Product Change Notification

Date Issued :	October 30, 2024	PCN Number :	516045
Reason for Change :	Equipment Transfer, Production Transfer or Rearrangement		
Description of Change :	This letter is to inform you that production of the part(s) identified in this notice is being moved to a different production location. No changes will be made to the product as a result of this move.		
Assessment of Change :	First Article Inspection		
Planned Implementation Date :	April 30, 2025		
Customer Sample Availability Date:	November 02, 2024		
Last date to request Samples by Customer :	November 30, 2024		
Please note if Samples are not requested as per Customer Samples Request date, it may take additional 4-6 weeks to arrange Samples.			
Traceability Code Markings / Date :	No special marking on the product or packaging

Change of plating production location

Before Picture

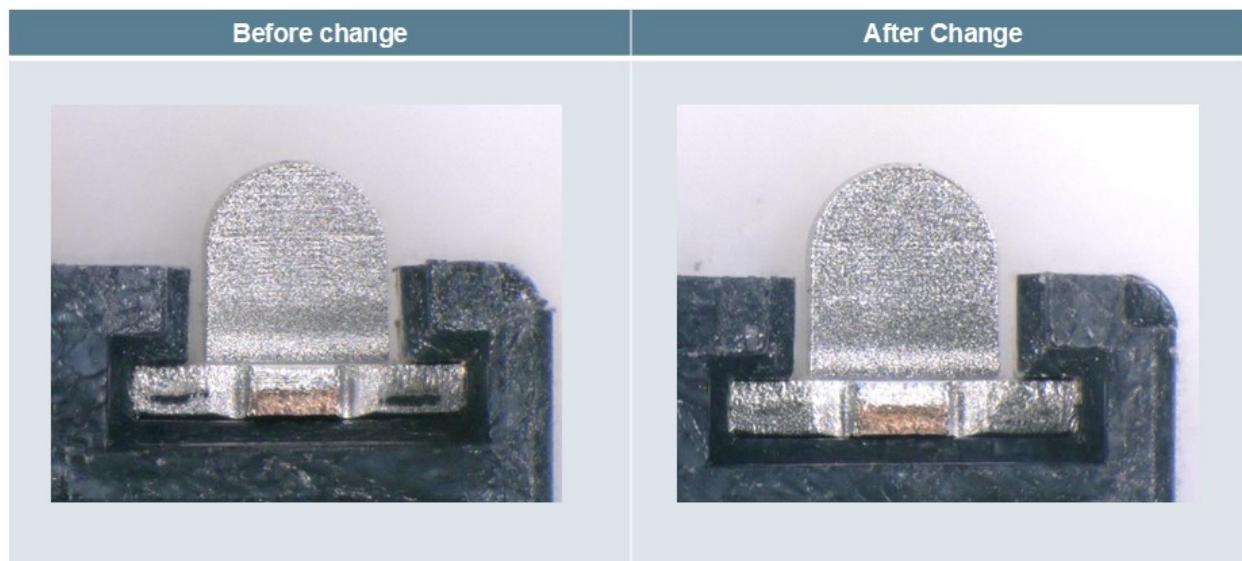
- We would like to transfer the plating production for the fitting nail of the 54363 Series from Molex Shizuoka to Japan Supplier, because plating line will be terminated due to facility reforming at Molex Shizuoka plant.

- None, no change to form, fit or function

- 543630289/543630389/543630489/543630589/543630689/543630778
